TITLE: TLD5542-1 Multichannel evalBoard

REV:
V4.5

Sheet: 3/3

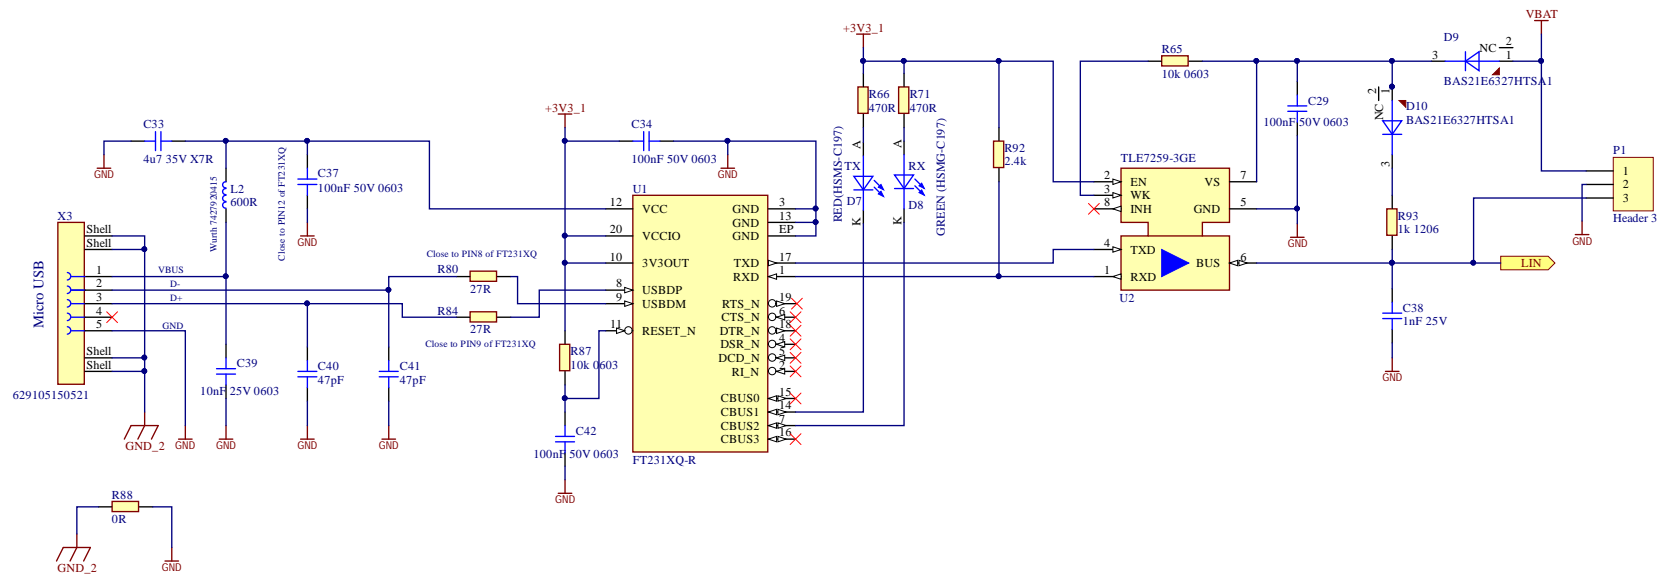
From V3.1 to 4.3
NONE
Modified R65 to 10k

From V2.1 to 3.1
Add a USB to LIN transceiver with schematic in the third page.

Sheet: 2/3

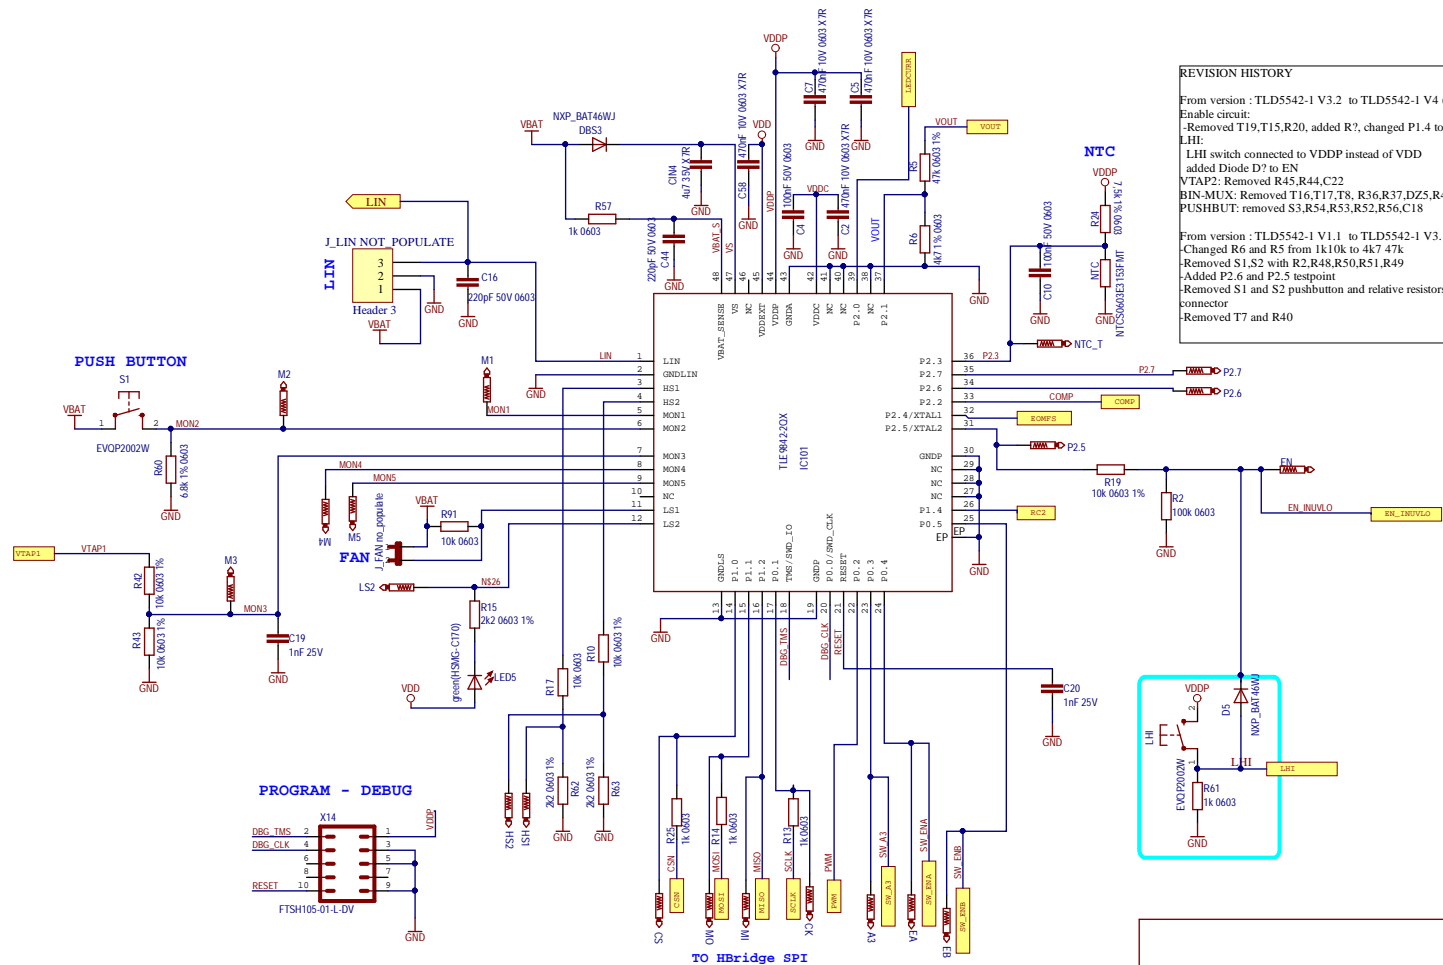
From version : TLD5542-1 V3.2 to TLD5542-1 V4 (3CH)

Enable circuit:

-Removed T19,T15,R20, added R7, changed P1.4 to P2.5

LHI:

LHI switch connected to VDDP instead of VDD

added Diode D7 to EN

VTAP2: Removed R45,R44,C22

BIN-MUX: Removed T16,T17,T8, R36,R37,DZ5,R46,C15,C11,R47,R39

PUSHBUT: removed S3,R54,R53,R52,R56,C18

From version : TLD5542-1 V1.1 to TLD5542-1 V3.1

-Changed R6 and R5 from 1k10k to 4k7 47k

-Removed S1,S2 with R2,R48,R50,R51,R49

-Added P2.6 and P2.5 testpoint

-Removed S1 and S2 pushbutton and relative resistors-Modified to 3 pin J_LIN connector

-Removed T7 and R40
